July 22, 2019

**SUBJECT: GOODMAN INDUSTRIAL PARK FONTANA III TRAFFIC IMPACT ANALYSIS DESIGN REFINEMENTS REVIEW**

**EXHIBIT B: PROJECT SITE PLAN**

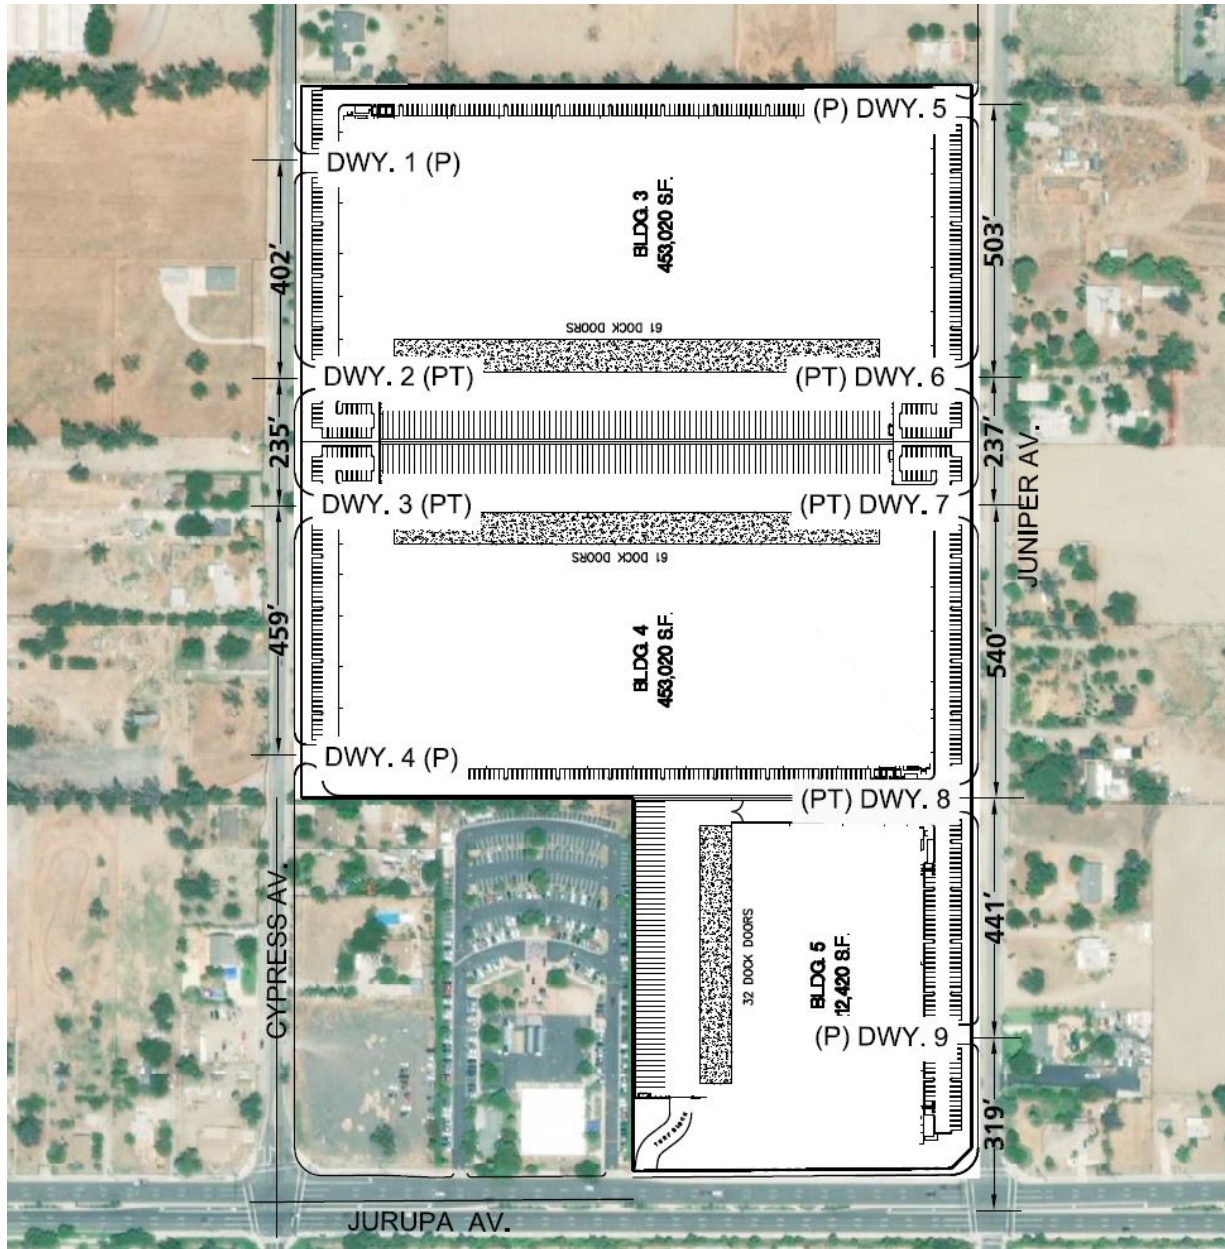
As shown on Exhibit B, the proposed driveway spacing between Driveways 2 and 3 is approximately 235 feet. This is less than the minimum driveway spacing standard of 330 feet per City of Fontana Access Management Criteria (City of Fontana Standard Plan 701). The purpose of the minimum driveway spacing guidelines is to improve the efficiency of the roadway system by minimizing conflicts. The minor reduction in driveway spacing enhances the efficiency of the roadway system by improving the movements of trucks into and out of the proposed driveways. If the driveways were to be spaced at 330 feet, this creates a less direct travel path and would cause slower truck movements.

The project engineer is proposing an offset of the driveway centerline that provides additional room for inbound trucks to complete their turns. The proposed inbound lane would be between 25 and 28 feet wide, leaving room for an outbound lane that is between 12 to 15 feet wide. The proposed shift of the centerline allows both inbound and outbound vehicles to complete their maneuvers without conflicts and allow inbound trucks to execute their turns from the outside travel lane.

The striping concept developed for Cypress Avenue provides for a slightly wider (18') outside lane, with associated narrowing of the inside lane. This also improves the ability of large trucks to enter the project site.

The proposed design refinements all serve to improve the movement of trucks into and out of the proposed project. It is recommended that these refinements be implemented in conjunction with the final project design. Urban Crossroads, Inc. is pleased to provide this letter report for your use. If you have any questions, please contact me directly at (949) 336-5981.
